# Stormwater Detention and Infiltration Design Data Sheet

# Markup Summary

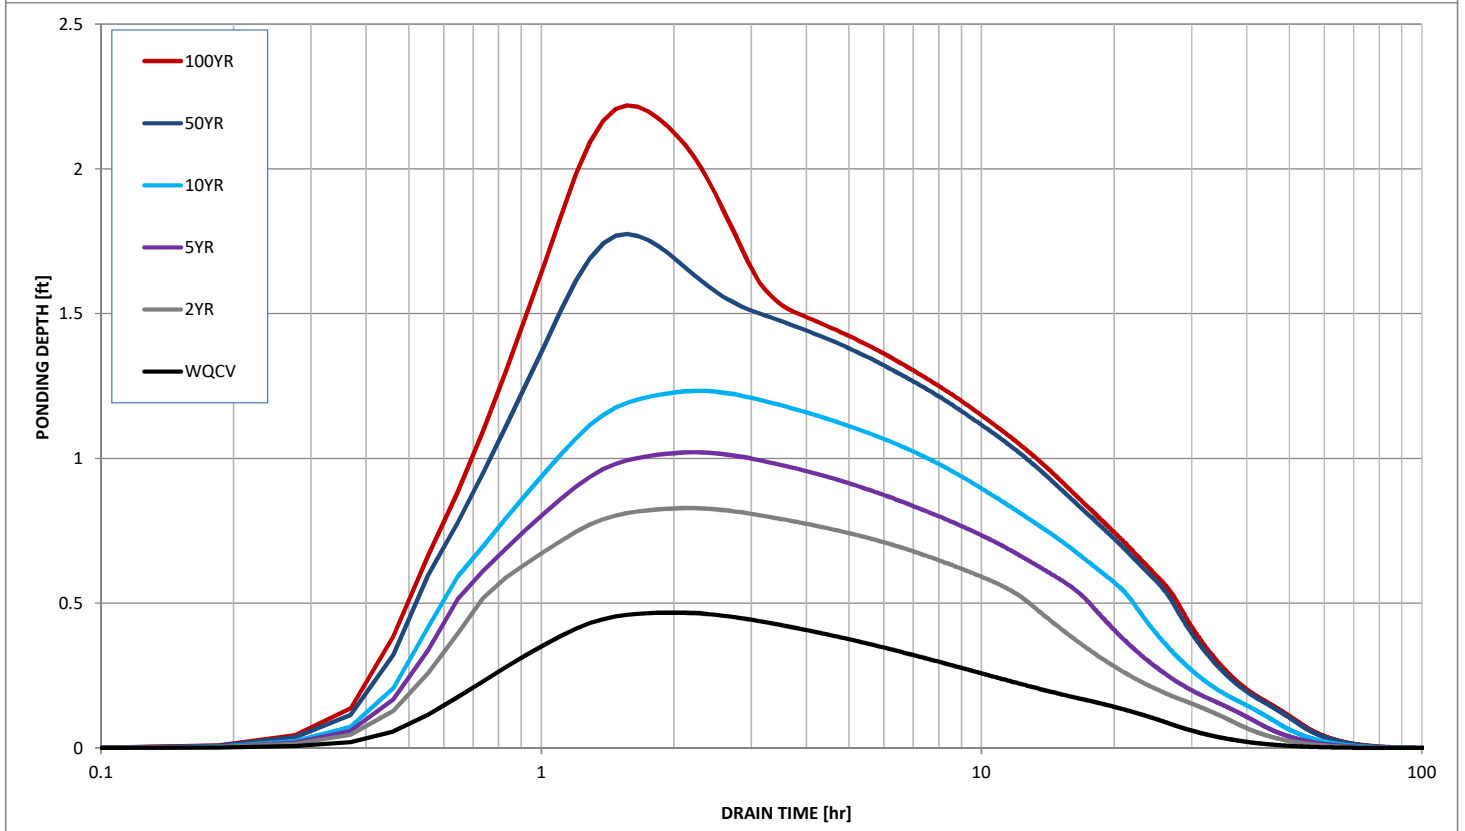
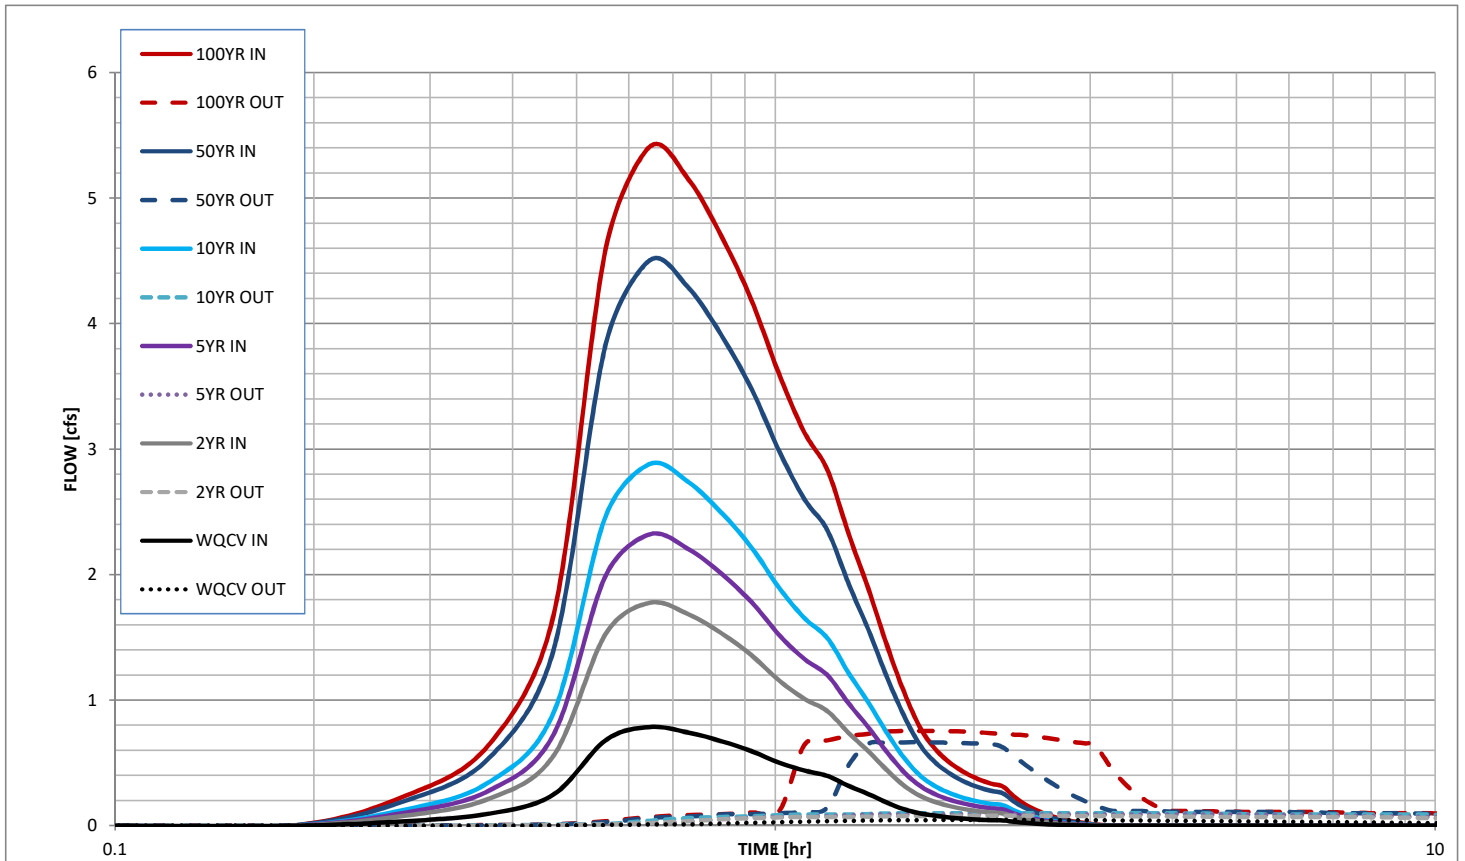
The underground detention should be modeled as Sand Filter with 12hr drain time.
